# NEXUS

AT 1200 HOWELL

#3021813  
07.12.2016  
DRB RECOMMENDATION MEETING

**RESPONSE** TO EDG COMMENTS

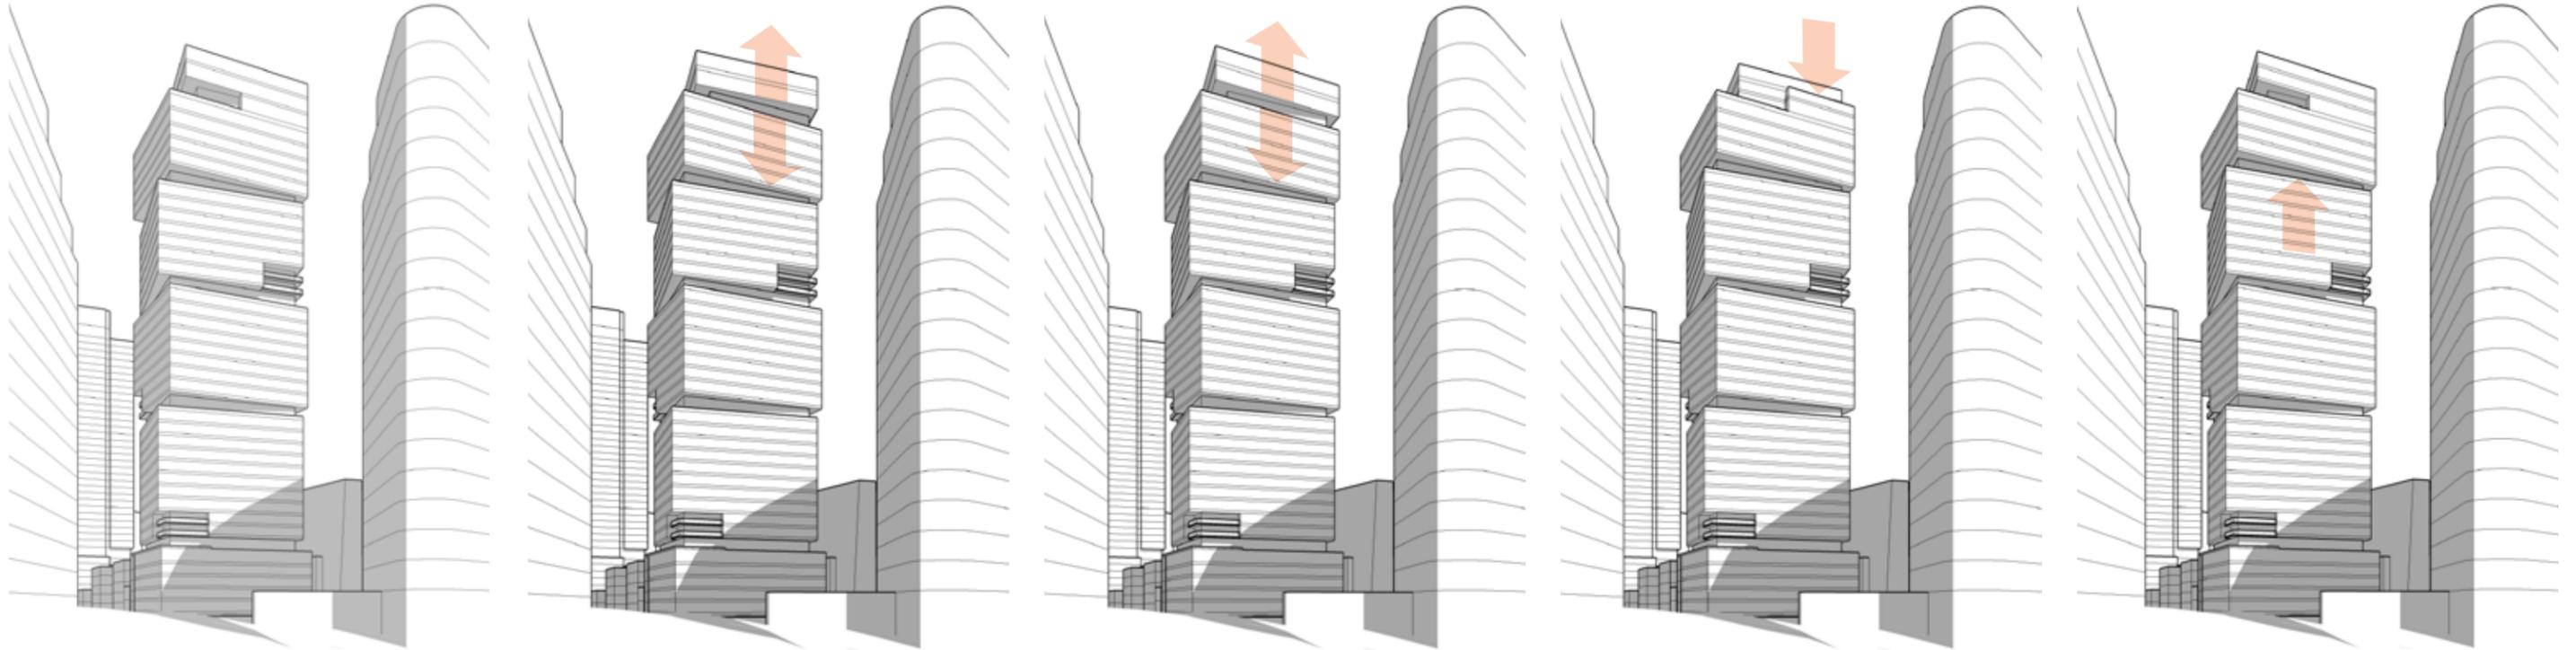
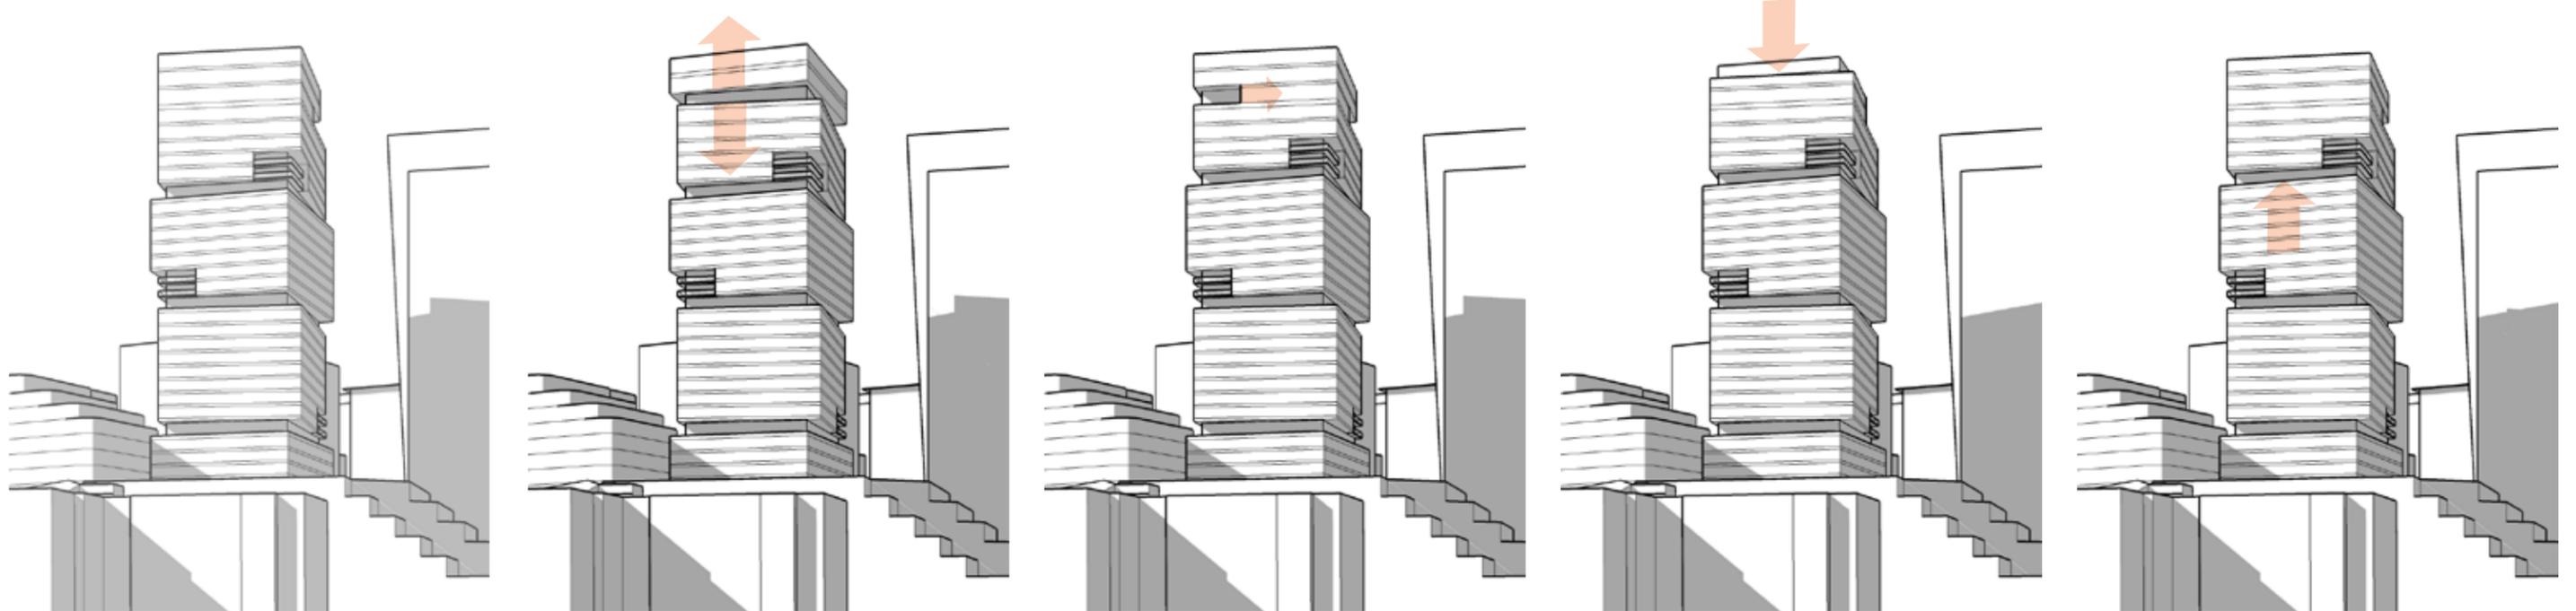
I. "At the EDG Meeting, the Board requested an **additional massing study** which **continues the shifting box form into the roof structure.**"

**1** The board suggested our massing from EDG was top heavy and did not fit into the stacked box language of the tower.

**2** The board requested a study with the mechanical space treated as another box in the tower, with the outdoor terrace wrapping all the way around RI. This creates a non-proportional box on the top that neither matches the language below nor is it aesthetically pleasing.

**5** Our solution maintains a similar massing to EDG but shifts the terrace level below up to proportionally match the top two boxes and maintain the hierarchy of the stacked boxes to the top. Hereby maintaining the architectural language from the major viewing angles (NE and SE) while preserving the proportionality.

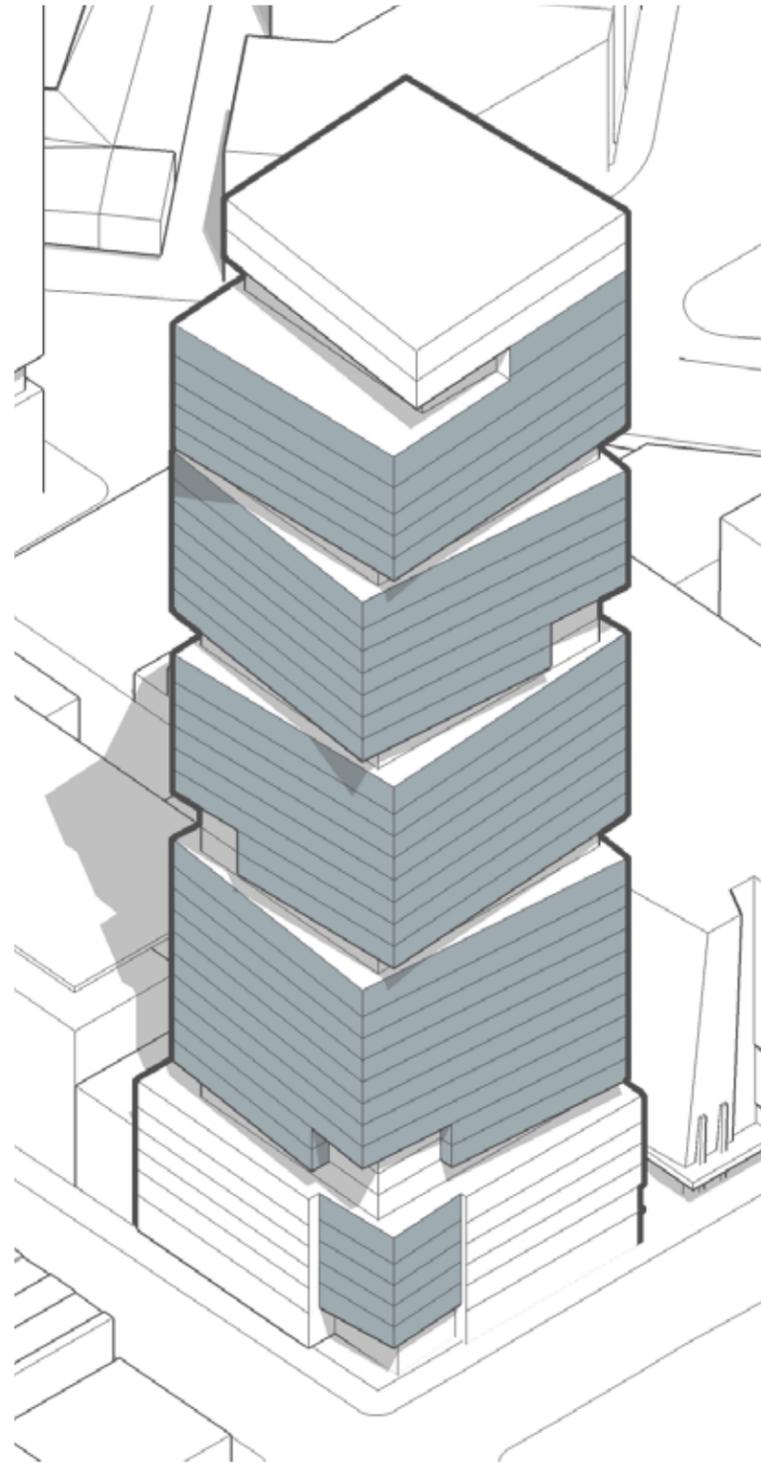
2. “The Board noted that the material treatment of the roof structure could either reinforce the tower material application or, alternatively, could be treated as separate element of the structure. **The Board felt the roof massing and material treatment should be reconciled with the overall design of the tower.**”

In response to the Board’s suggestions, the facade treatment at the top of the tower has been reconciled with the rest of the tower, creating a unified architectural statement.

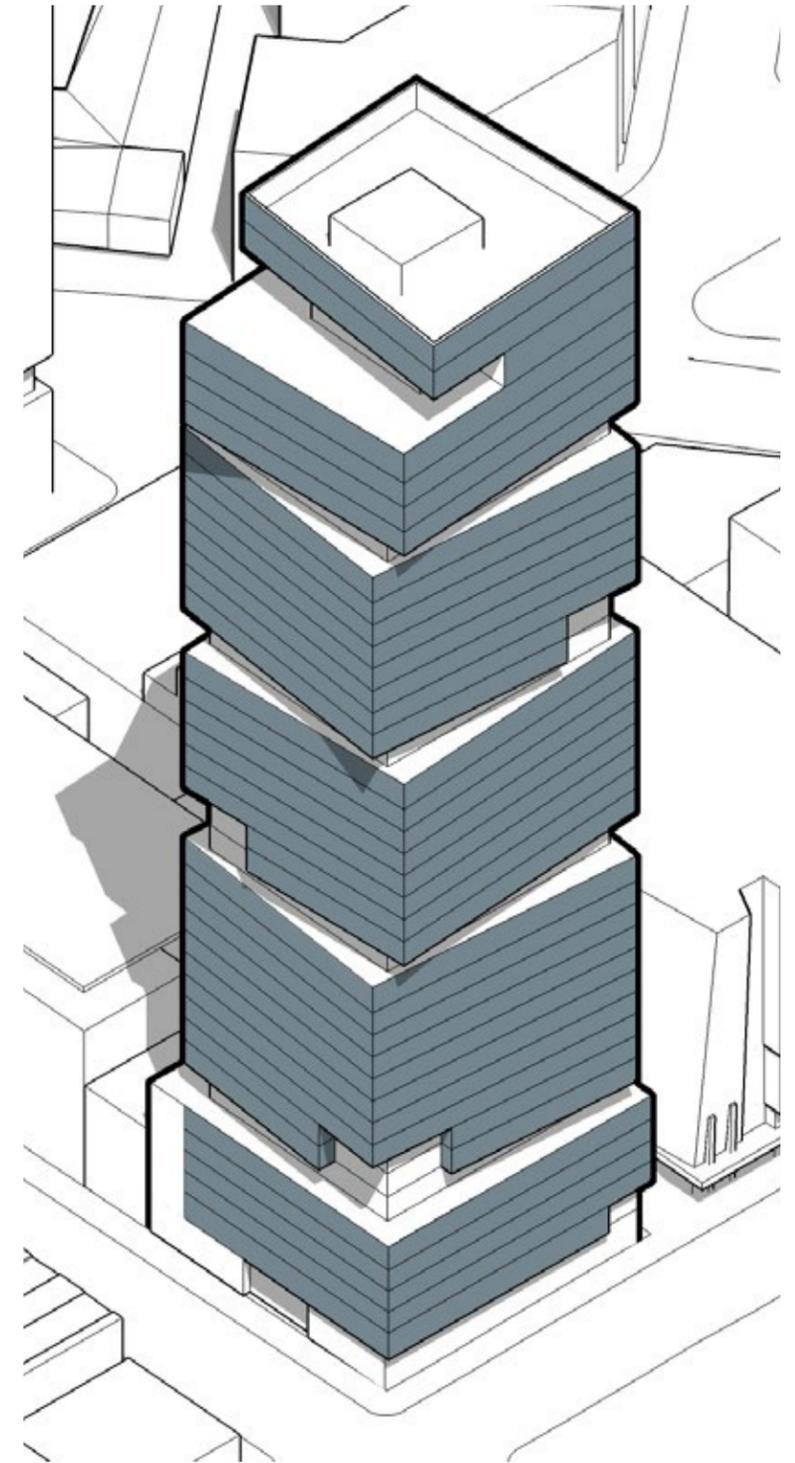
3. "At the EDG Meeting, the Board requested additional study incorporating the **podium into the overall stacked box tower architecture.**"

The proposed design now carries the facade treatment and language of the boxes down into the podium's entire massing.

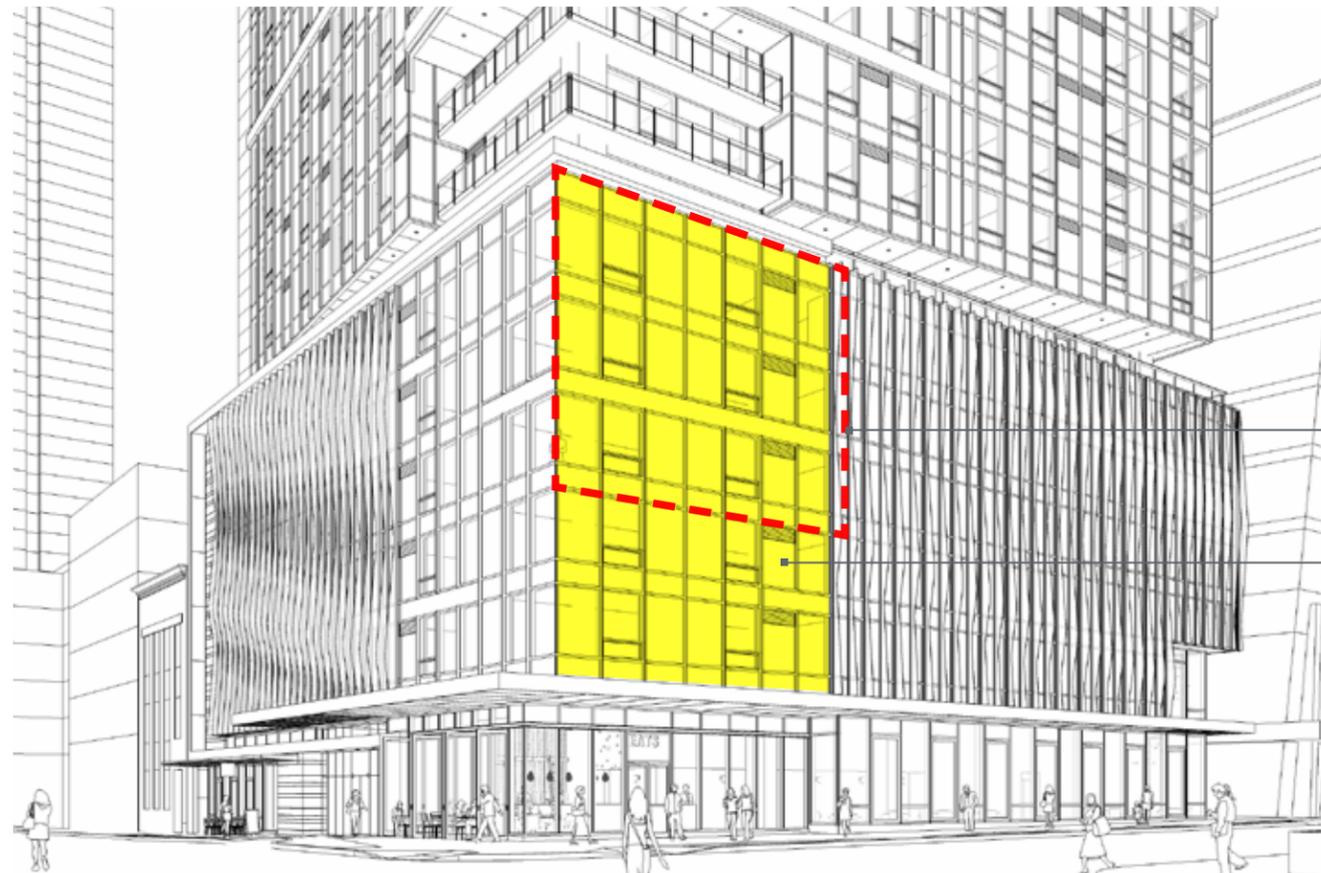
The residential façade area separating the parking on levels 4, 5 and 6 along Howell does not meet the 30% requirement

30% of 120ft would equal a required length of separated use of 40ft. Along Howell we currently provide 38'-8" of separated use, but provide that over all 5 levels instead of just 4,5,6 netting to a much larger area of separated use than the Code requires. (1,870sf vs 1,235sf that would meet the 30% on L4-6)

**At EDG the Board supported the applicant's strategy to separate the parking with residential units, with the caveat that the rest of the podium design be resolved with adequate screening for the parking.** Allowing this departure would result in a significantly increased area of podium activation that would be located closer to the sidewalk where it could be better appreciated from the street level. While we are currently just slightly under the required 30% on all required floors, the resulting increased area of activation strengthens the building and the neighborhood.

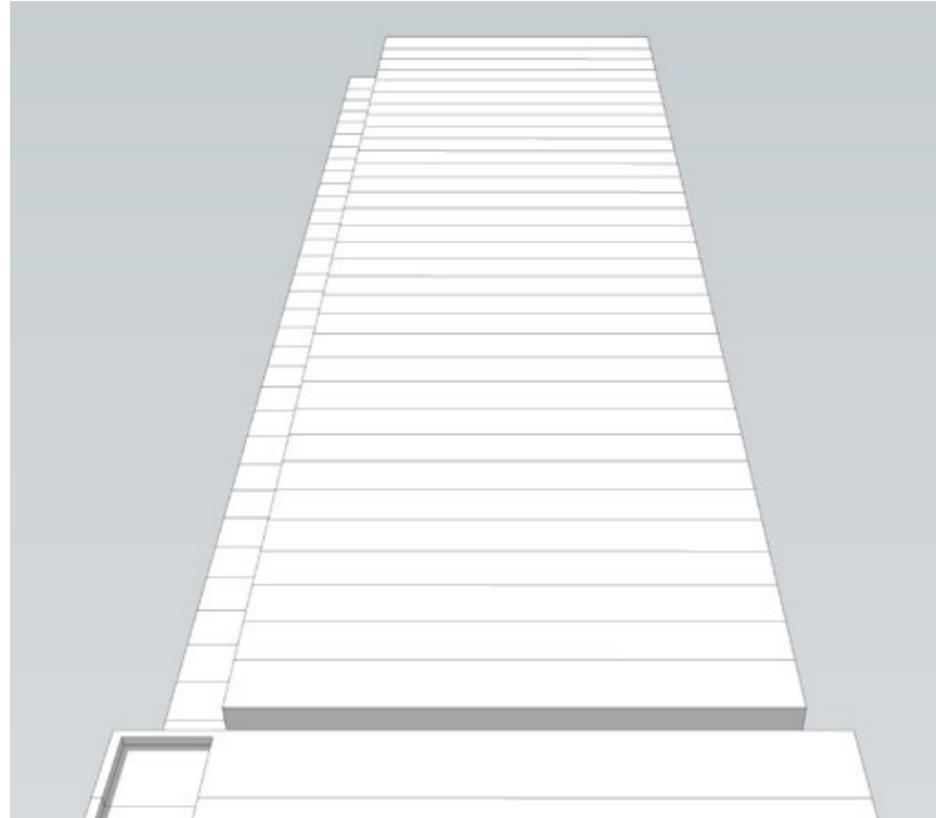
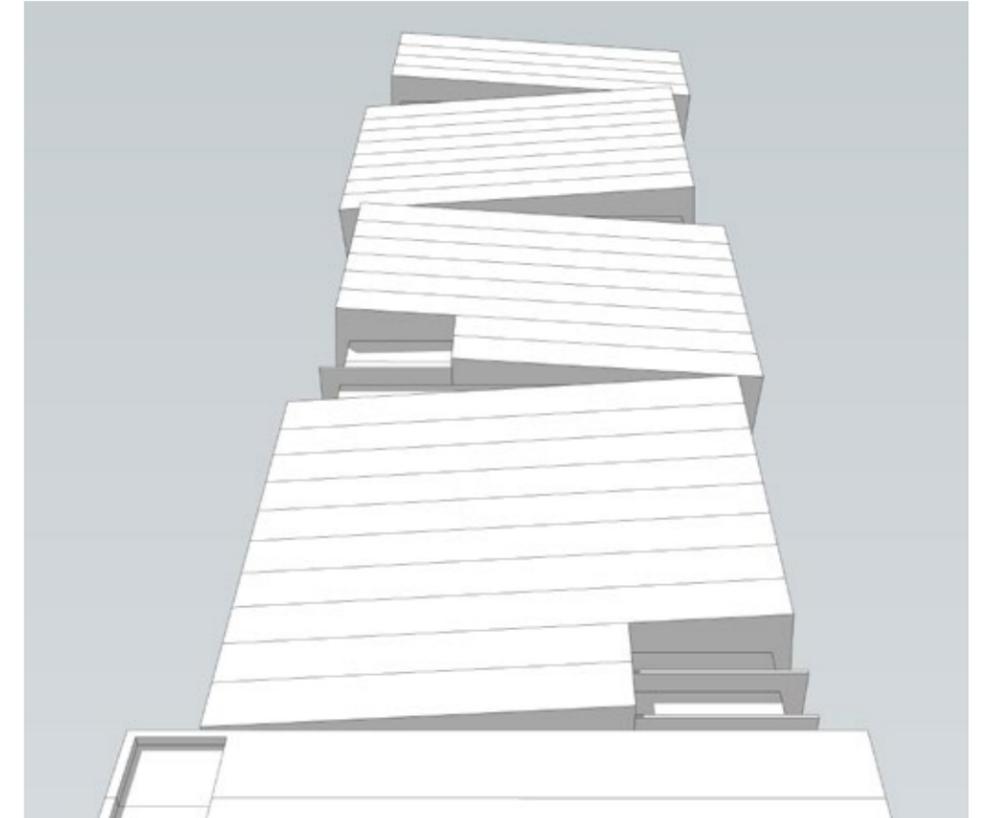
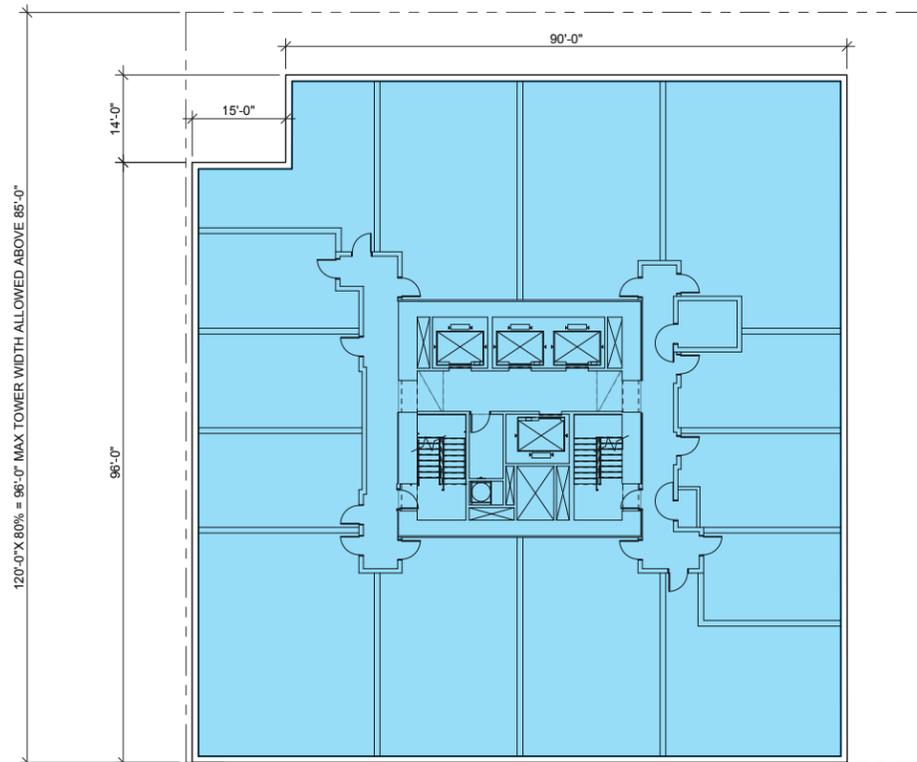
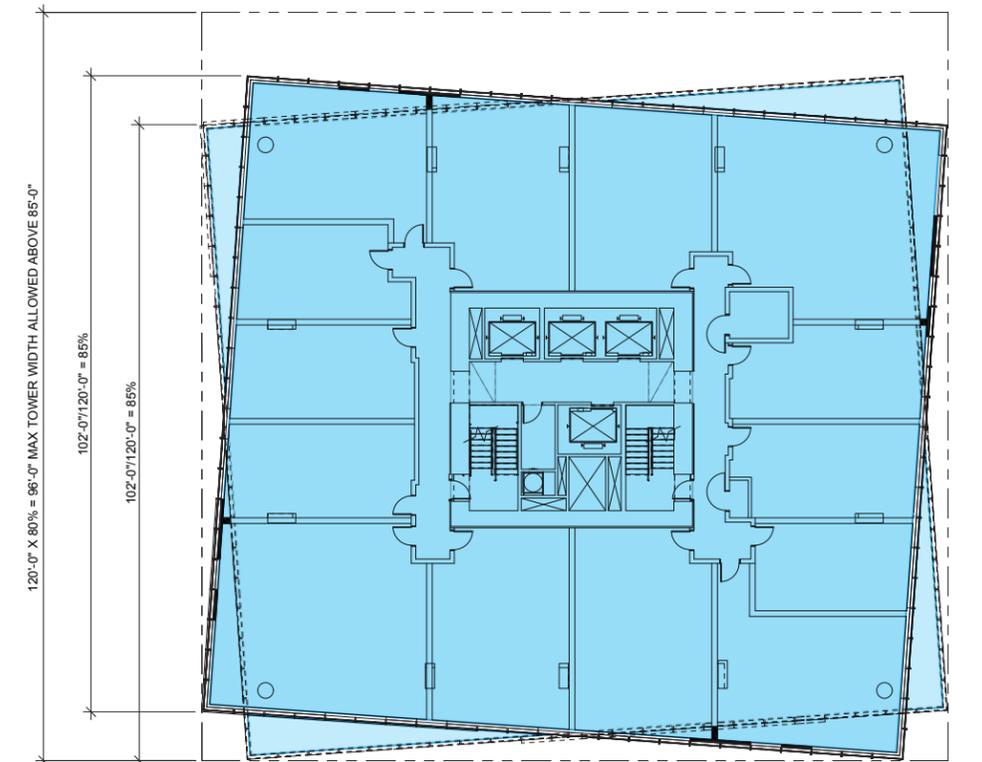
The length of the N/S facade along Minor Ave. is longer than the maximum allowed

The facade width along Minor Ave. is 102', 6" longer than the 96' max (85% of 120')

We propose that although the west facade (along Minor Avenue) exceeds the maximum width of 80% of the lot, the resulting perspective created by the shifting series of boxes moving apart from one another, in addition to the eroded corners of the boxes, is equally effective in minimizing the appearance of the tower's width. By allowing this departure – the massing can take a more dynamic and interesting form while remaining under the required 10,700 average floorplate size. **At EDG the board supported this departure**
